Subject: Virgil C. Summer Nuclear Station  
Docket No. 50/395  
Operating License No. NPF-12  
Spent Fuel Pool Rerack Modification

In a letter dated January 23, 1984, South Carolina Electric and Gas Company (SCE&G) requested approval from the Nuclear Regulatory Commission (NRC) for a proposed rerack modification to the spent fuel pool at the Virgil C. Summer Nuclear Station. In letters dated March 6, 1984, April 4, 1984, April 17, 1984, May 11, 1984, May 18, 1984 and May 30, 1984, SCE&G provided responses to NRC Staff questions on the proposed rerack modification. This letter is provided in response to additional questions raised by the Staff in the modification review process.

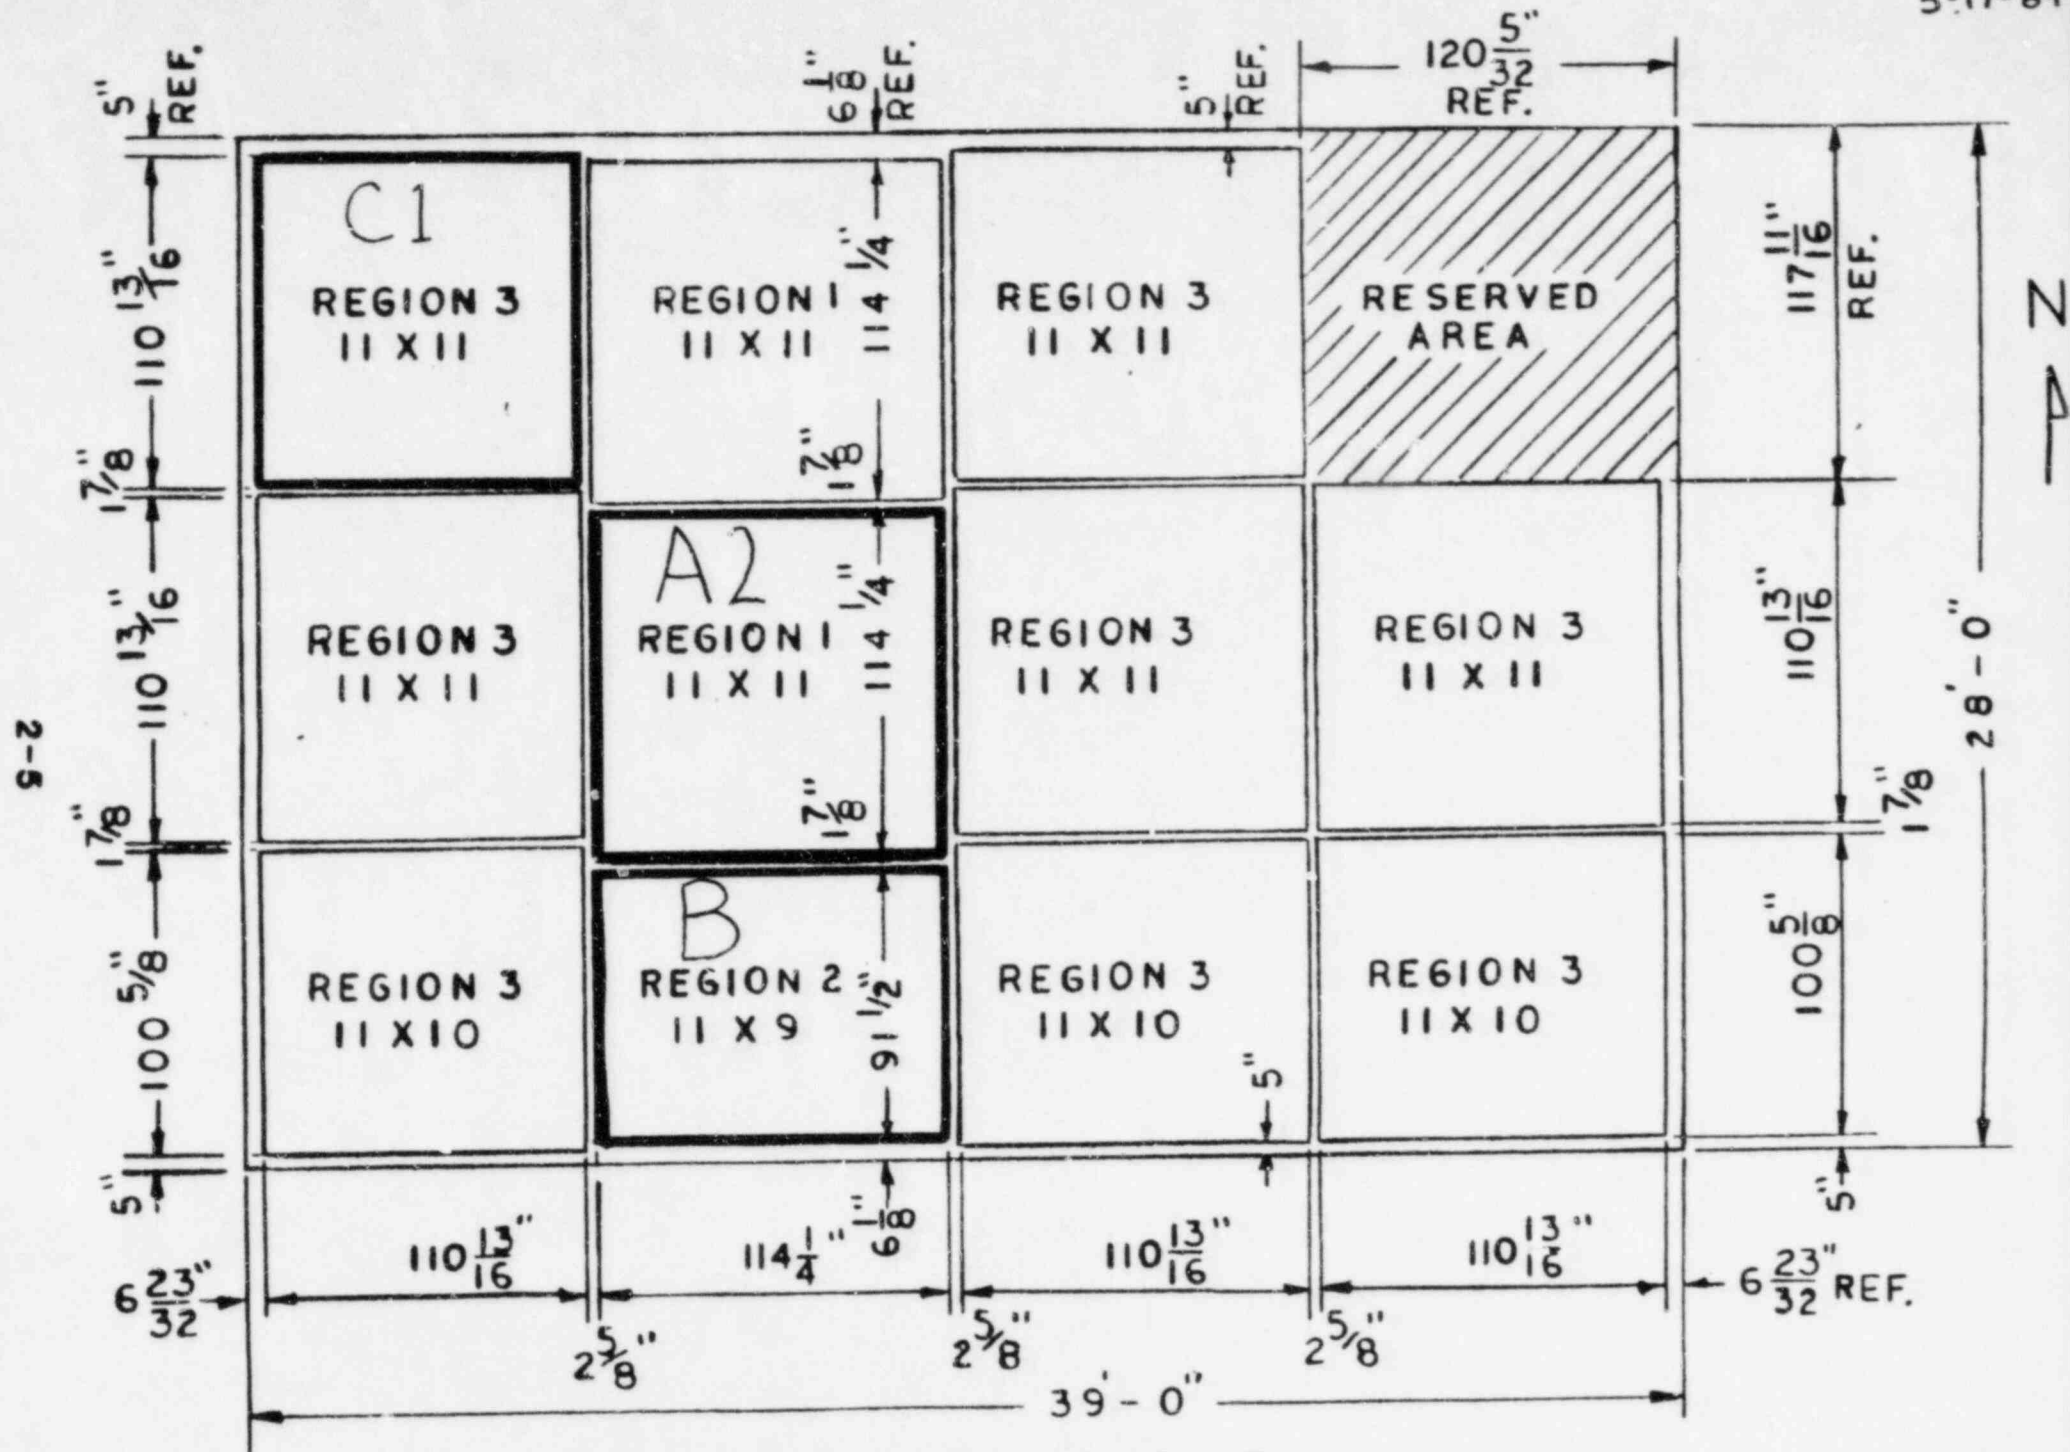
The third question asks for further clarification on which modules were seismically analyzed supplemented by more detail on the analysis results. Detailed analyses were performed on racks A2 and C1 (see attached Figure 2.1). These were the largest modules and representative of the different types of

# Attachment 2

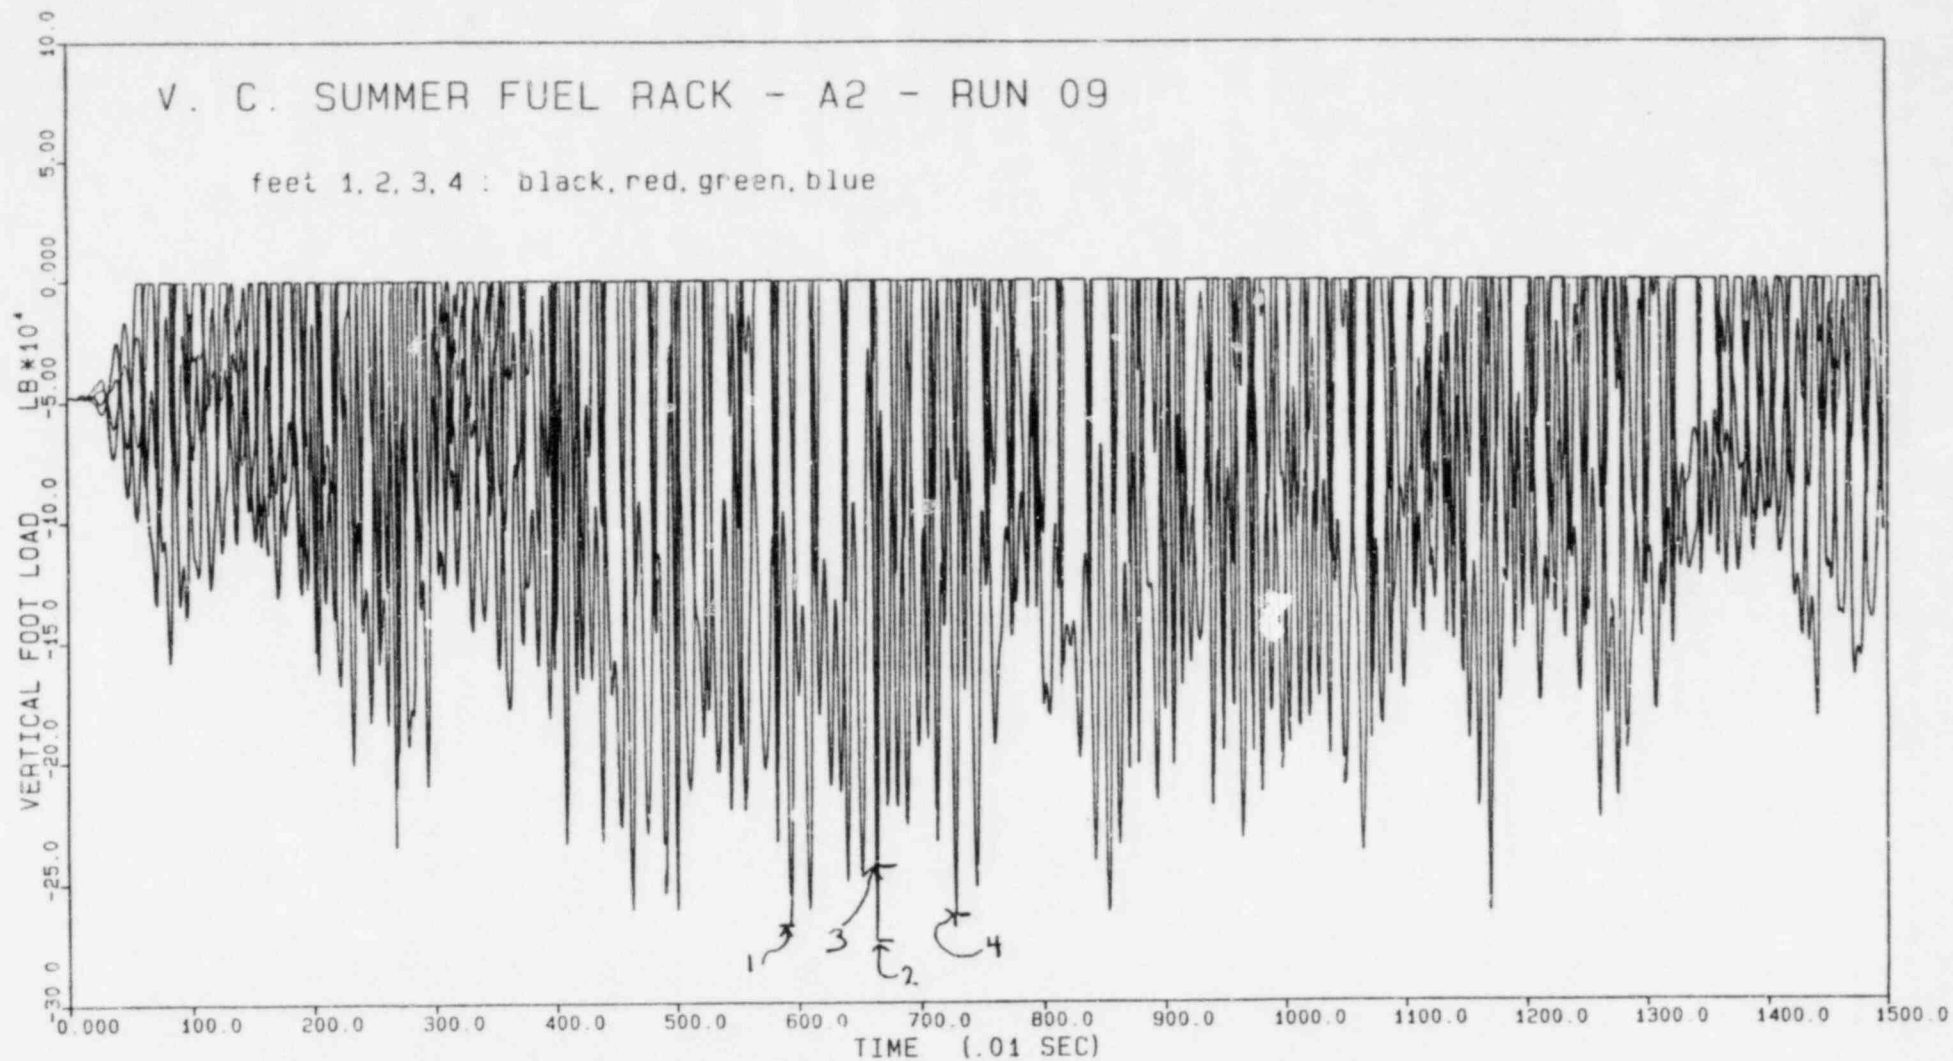
internal constructions used in the separate regions. The vertical reaction histories for racks A2 and C1 are enclosed as attachments 2 and 3, respectively. These rack histories assume the SSE case with a coefficient of friction equal to .8.

## STRUDL MODEL (NORTH-SOUTH)

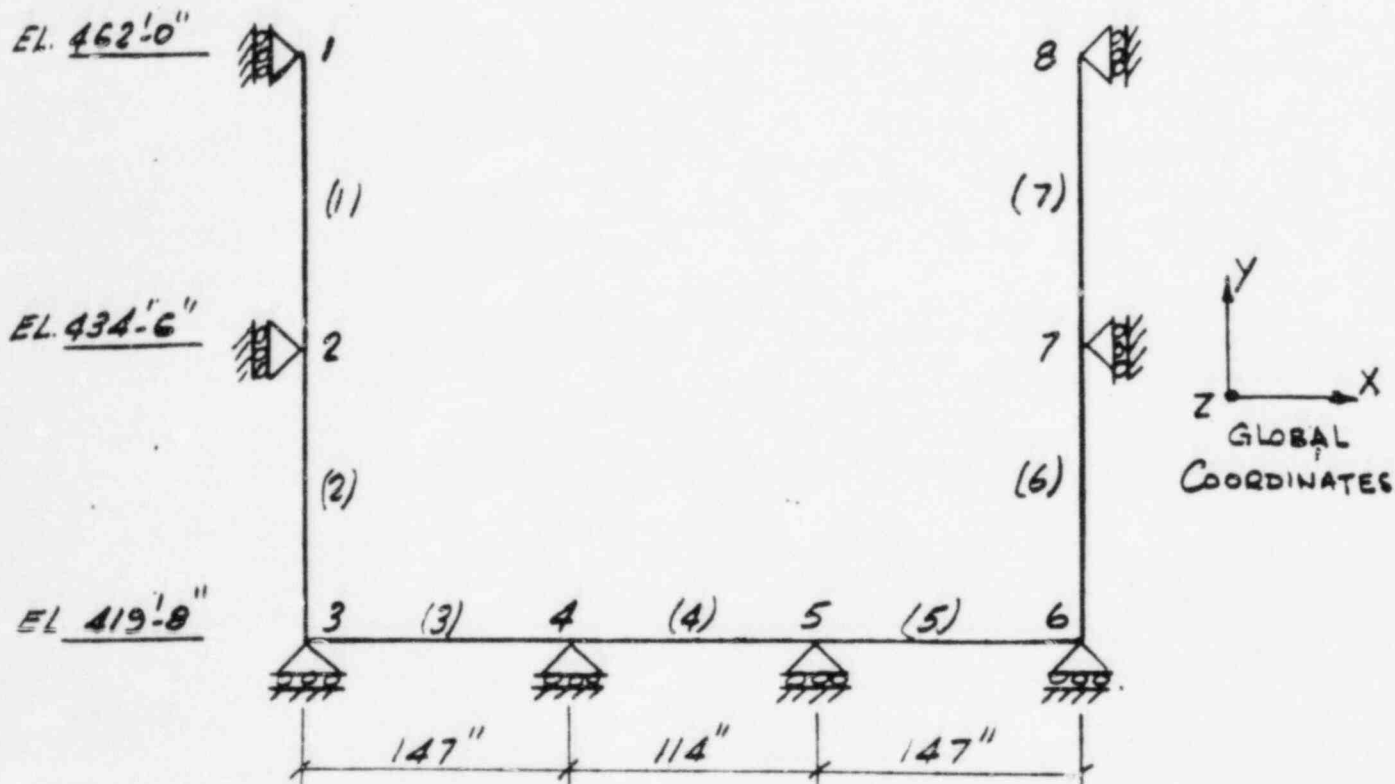
The seventh question requests information on the model and computer code used for the spent fuel pool structural analysis. The computer code used for the re-evaluation of the pool structure under the new rack loading is "Inhouse McAuto ICES STRUDL, GAI Program #S110 Revision 3," certified to Gilbert Associates' Computer Application Manual (CAM). The models used for this analysis are shown on the enclosed attachments 4 and 5. The beam strip theory was considered to be a conservative analysis method because of the thickness of the slab in relation to the span and column width.
